Detroit Edison Company Response to NRC Request for
Additional Information Letter No. 37, Attachments 4-5
(August 13, 2010)

Subject: Detroit Edison Company Response to NRC Requests for Additional Information Letter No. 37

**Response to RAI Letter No. 37
(eRAI Tracking No. 4812)**

**Response to RAI Letter No. 37
(eRAI Tracking No. 4813)**

Figure 13.1-201 Design and Construction Organization

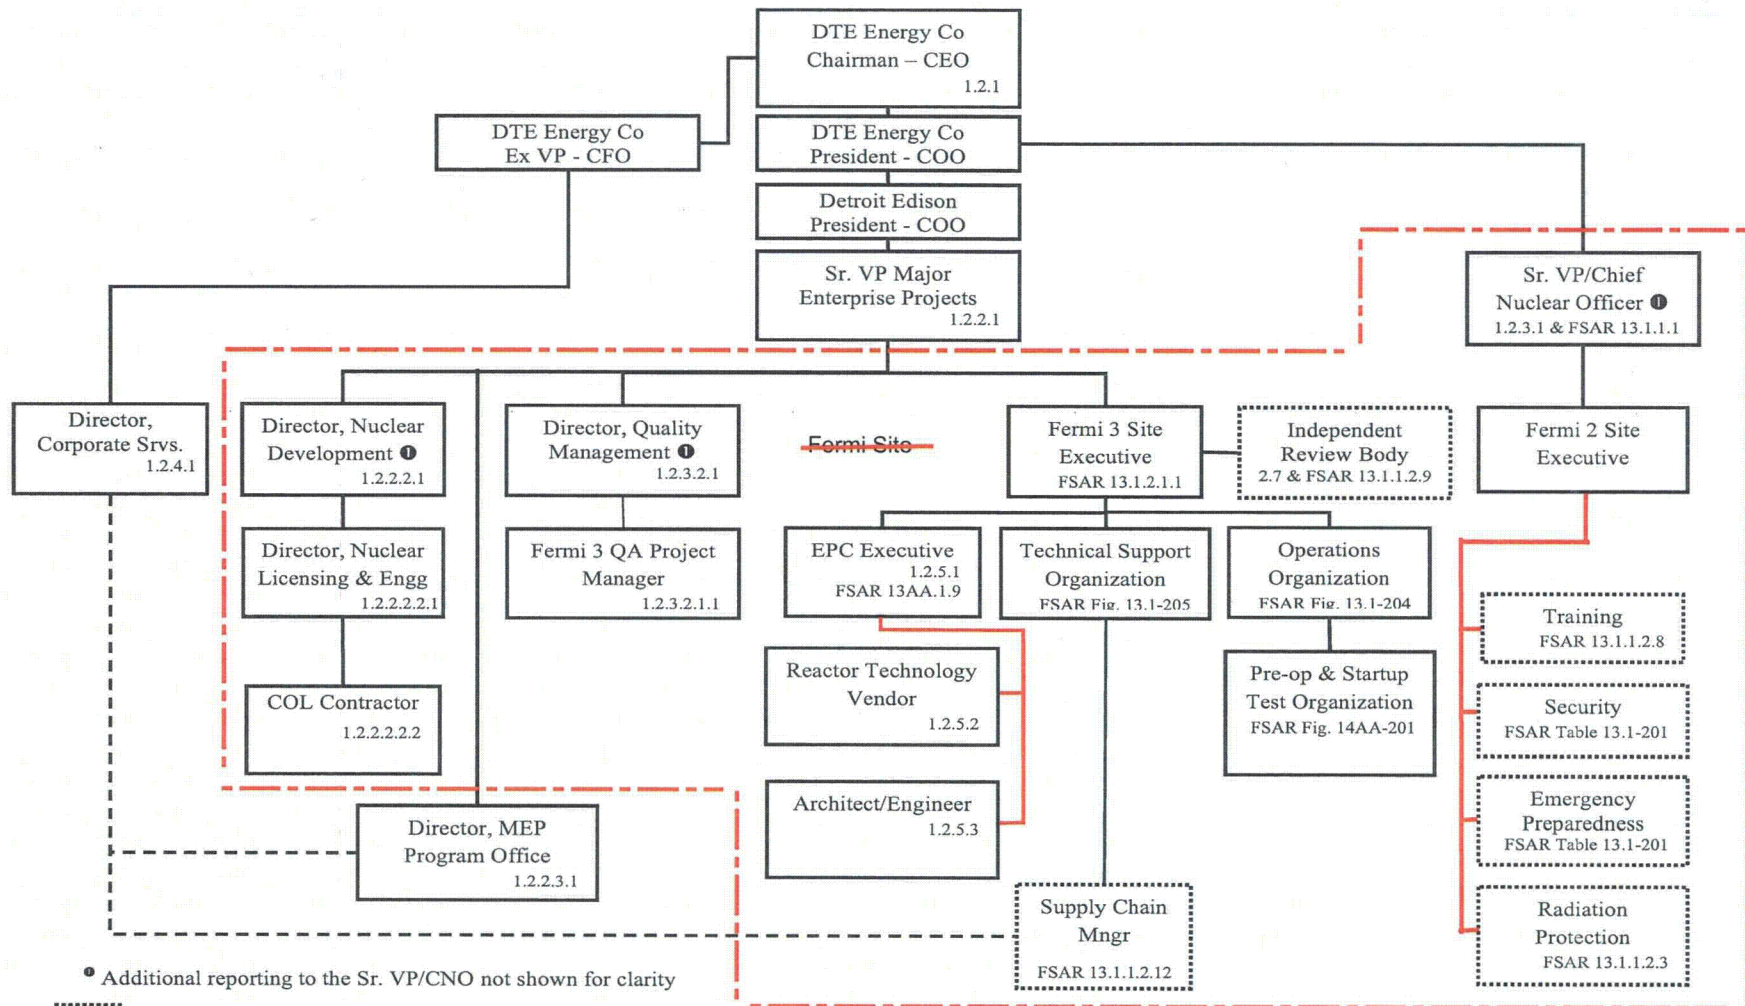
- b) QAPD Figure II.1-2, "Design and Construction Organization (Insert 15)," depicts the Architect/Engineer (1.2.5.3) position without a reporting line. Please clarify the Architect/Engineer reporting structure.*

- b) *QAPD Figure II.1-2, "Design and Construction Organization (Insert 15)," depicts the Architect/Engineer (1.2.5.3) position without a reporting line. Please clarify the Architect/Engineer reporting structure.*

The Architect/Engineer (AE) reports to the Engineering Procurement Construction (EPC) Executive. QAPD Figure II.1-2 and FSAR Chapter 13 Figure 13.1-201 will be revised to clarify this reporting relationship.

Fermi 3 QAPD Section 1.2.2.2.1, QAPD Figures II.1-2 and II.1-3, and FSAR Chapter 13 Figure 13.1-201 will be revised as shown on the attached markups to address the issues discussed above.

**Figure II.1-2
Design and Construction Organization**

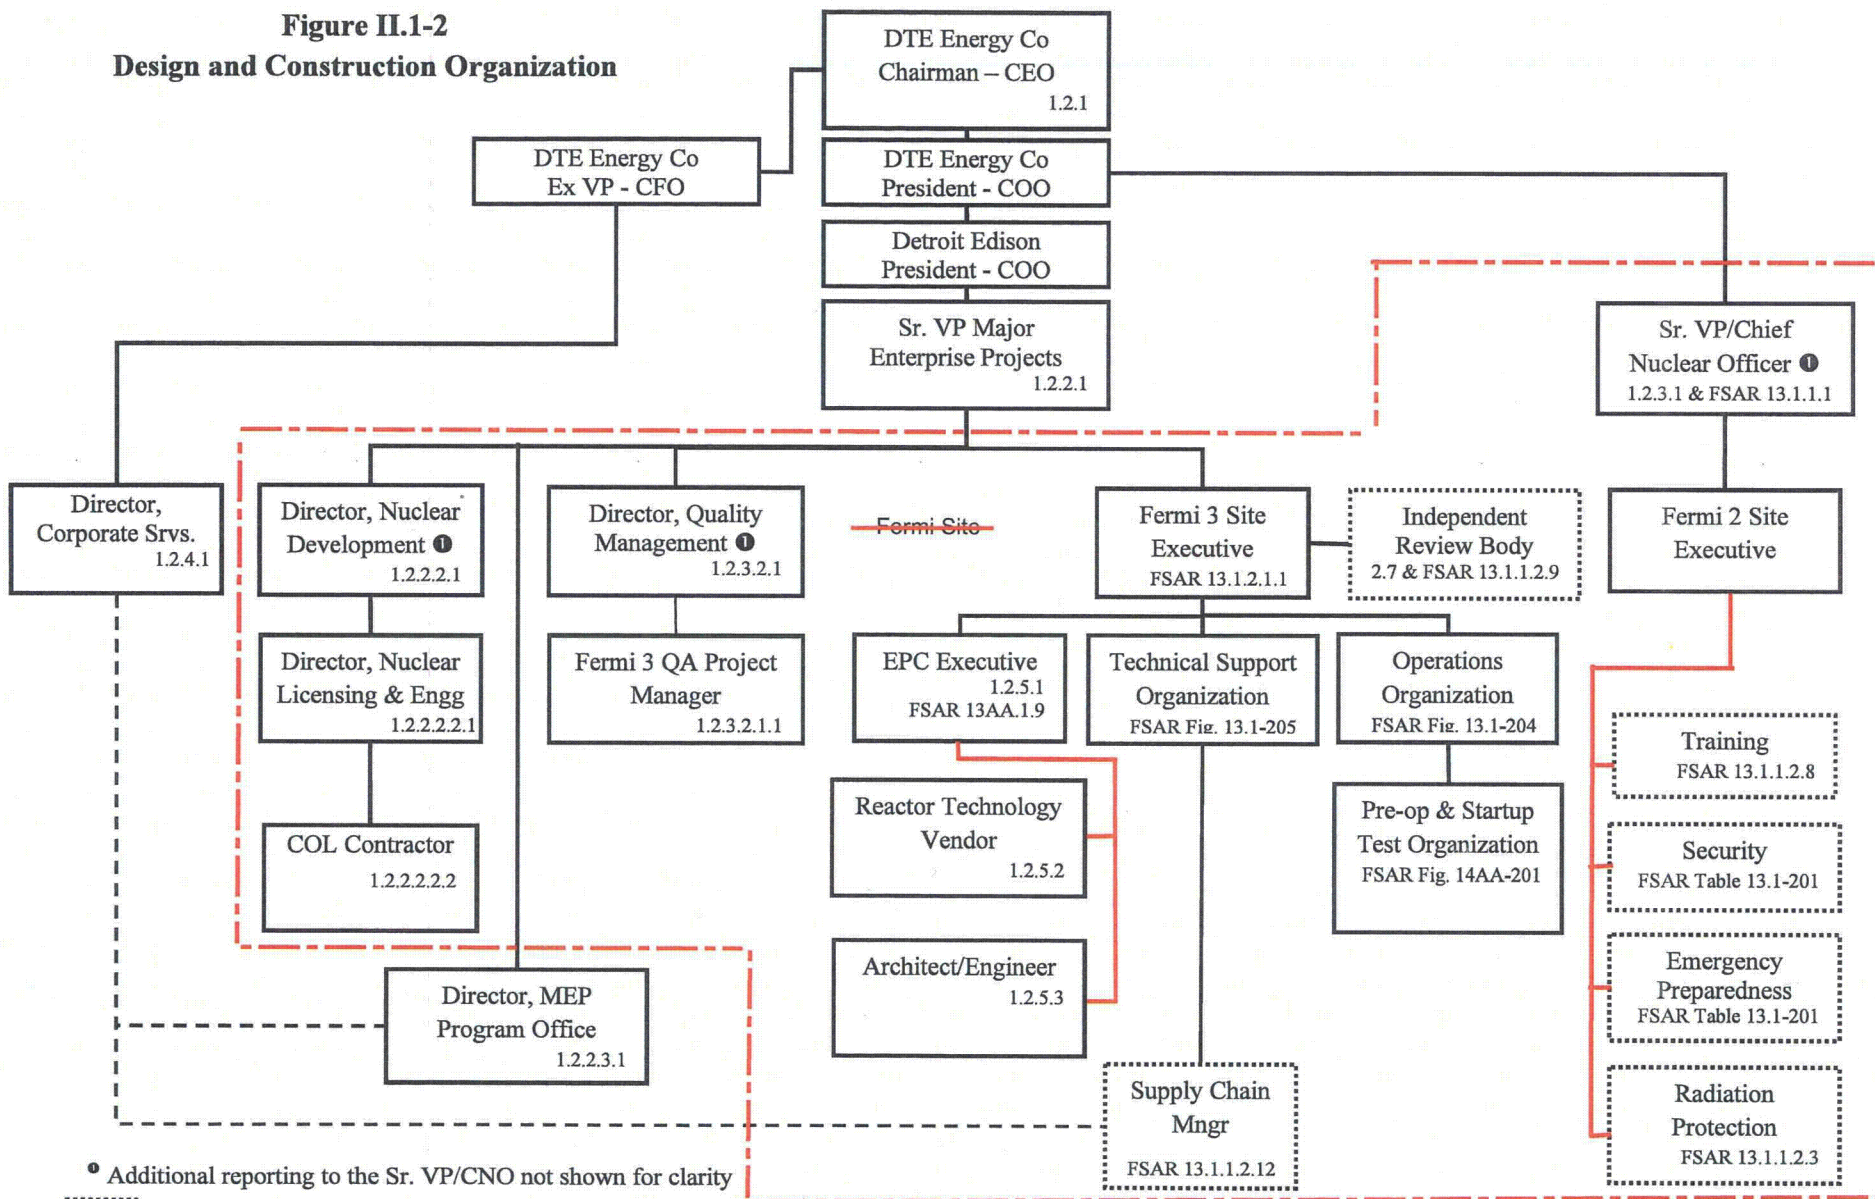
- d) Both QAPD Figure II.1-2, "Design and Construction Organization (Insert 15)," and QAPD Figure II.1-3, "Fermi 3 Site Organization (Insert 16)," show all Fermi 3 QA positions located offsite. Please include any onsite QA personnel in the position*

- d) *Both QAPD Figure II.1-2, "Design and Construction Organization (Insert 15)," and QAPD Figure II.1-3, "Fermi 3 Site Organization (Insert 16)," show all Fermi 3 QA positions*

The organizational descriptions of the Design and Construction phase Site Organization (QAPD Section 1.2.3.3), and the Operations phase Fermi 3 Site Organization (QAPD Section 1.3.3) do not exclusively define organizational locations, the titles are representative of the functions of the organizations, not the locations of these organizations. Fermi 3 QAPD Figures II.1-2 and II.1-3 will be revised to clarify that Fermi 3 QA positions will be located on the Fermi site.

**Figure II.1-3
Fermi 3 Site Organization**

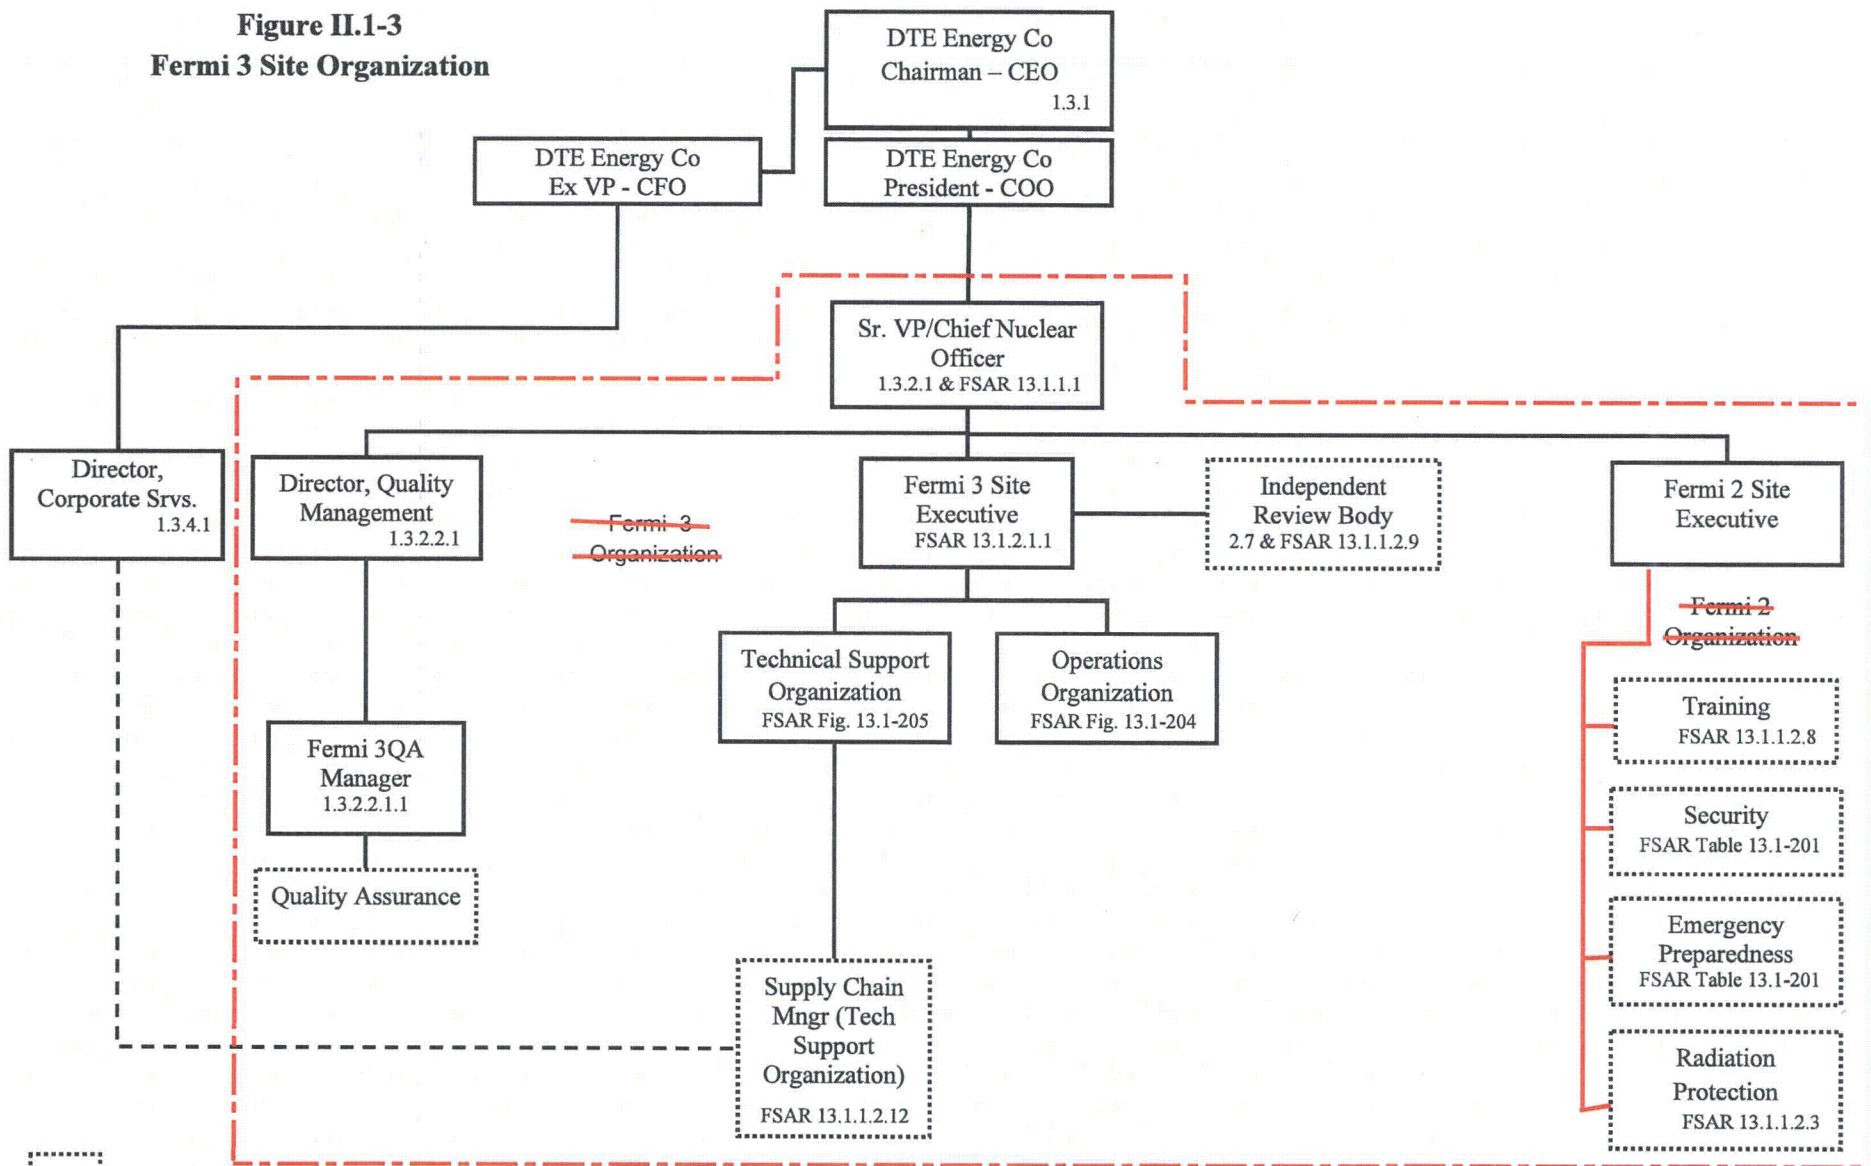
- c) QAPD Figure II.1-3, "Fermi 3 Site Organization (Insert 16)," appears to indicate all depicted positions are located onsite (based on the title), but some positions appear to be corporate positions. Please clarify which positions are located on the Fermi site.*

- c) *QAPD Figure II.1-3, "Fermi 3 Site Organization (Insert 16)," appears to indicate all depicted positions are located onsite (based on the title), but some positions appear to be corporate positions. Please clarify which positions are located on the Fermi site.*

Within QAPD Figure II.1-3, "Fermi 3 Site Organization", the Chief Executive Officer (CEO), Chief Operations Officer (COO), Chief Financial Officer (CFO), and Director Corporate Services positions are not located on the Fermi site. All other positions represented on Figure II.1-3 are anticipated to be located onsite. QAPD Figure II.1-3 will be revised to clarify position locations. The organizational descriptions of the Design and Construction phase Site Organization (QAPD Section 1.2.3.3), and the Operations phase Fermi 3 Site Organization (QAPD Section 1.3.3) do not exclusively define organizational locations, the organizational titles are representative of the responsibilities and functions of the organizations, not the locations of these organizations. Fermi 3 QAPD Figures II.1-2 and II.1-3 will be revised to clarify position locations.
